Mack Trucks, Inc.
Greensboro, NC USA

Service Program Trucks

Transmission Cooler Line O-Ring
CHU, CXU, GU, TD

PI0787, Transmission Cooler Line O-Ring

W4072905

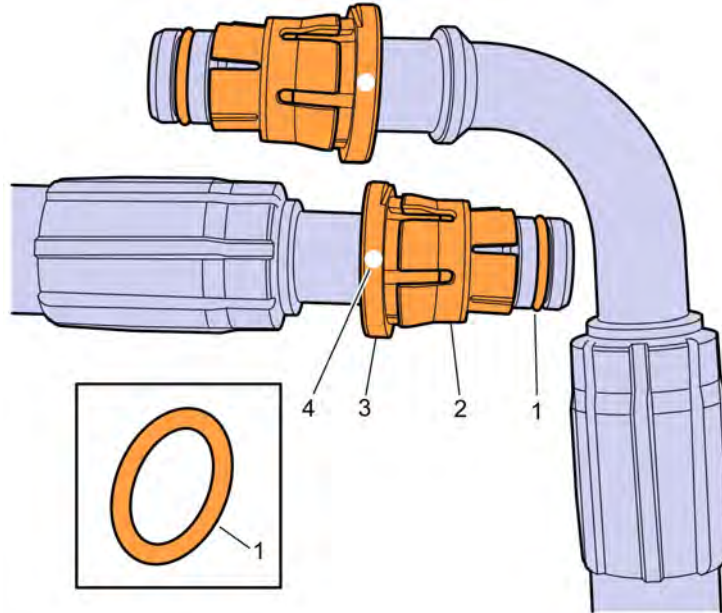
Certain MACK trucks built between January 01, 2012 and March 05, 2012 may have been assembled with an incorrect o-ring installed on the transmission cooler line fittings. The transmission cooler line fittings are located at the bottom of the radiator where the transmission cooler lines connect to the transmission. The incorrect o-ring may not seal properly, causing transmission fluid loss and/or premature transmission damage.

Trucks built after March 05, 2012 were assembled with a replacement o-ring on the transmission cooler line fittings. A white dot on the shoulder of the fitting cap indicates a replacement o-ring was installed during assembly. See figure below. Visually inspect the truck for a white dot on the shoulder of the fitting cap. If the white dot is visible, only an inspection for the white dot is required. If the white dot is not visible on the fitting cap, replace the existing o-ring with a new green o-ring (part number 21866819). See the o-ring replacement procedure on page 2.

Transmission Cooler Line Fitting Components		
Item #	Part Number	Description
1	21866819	O-Ring
2	85129501	Locking Collar
3	85131659	Cap
4	N/A	Visual Inspection Mark (White Dot)
